Work Order ID 62457

Item Name: Head Rest

DRAWING NO. D3303	TITLE HEAD REST	REV. B	DART AEROSPACE LTD ENGINEERING ORDER		D.E.O. NO. D3303-B-1	SHEET NO. SHEET 1 OF 1	SCALE NTS
DRAWN AJS	CHECKED <i>L</i>	MFG. APPR. <i>MA</i>	APPROVED <i>MA</i>	DE APPR. <i>MA</i>			
DATE 08.10.15	DATE <i>08.10.15</i>	DATE <i>08/10/16</i>	DATE <i>08/10/16</i>	DATE <i>08/10/16</i>

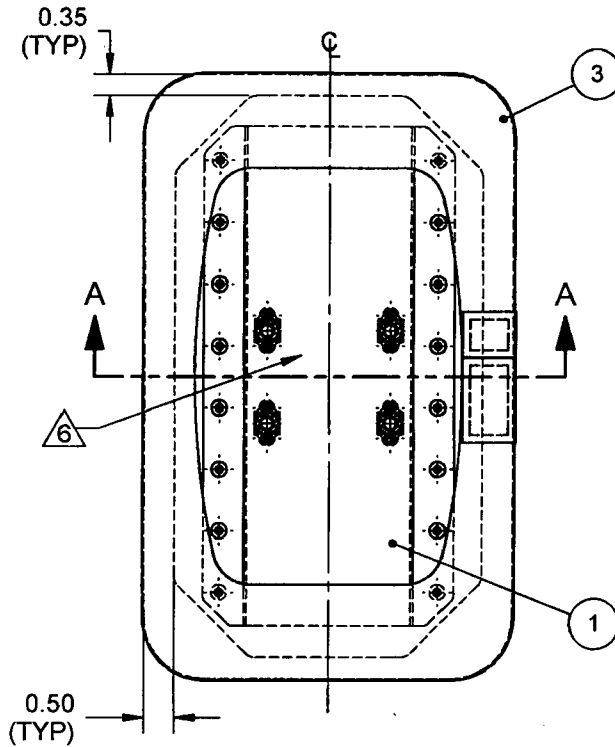
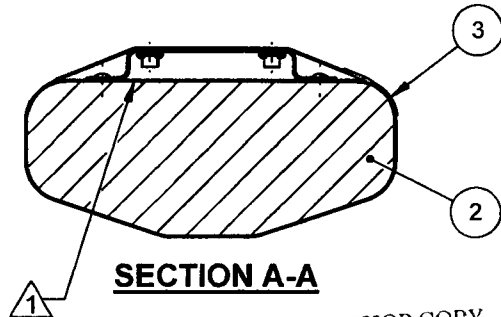
SHEET 1 ADD 1300L ADHESIVE BY 3M TO NOTE 1 AS FOLLOWS:

WAS:

- 1) BOND D3305-1 FOAM TO D3303-043 BRACKET ASSEMBLY USING 3M 1300 ADHESIVE (0.002" TO 0.010" THICK) IN ACCORDANCE WITH MANUFACTURER'S INSTRUCTIONS

IS:

- 1) BOND D3305-1 FOAM TO D3303-043 BRACKET ASSEMBLY USING 3M 1300 OR 1300L ADHESIVE (0.002" TO 0.010" THICK) IN ACCORDANCE WITH MANUFACTURER'S INSTRUCTIONS
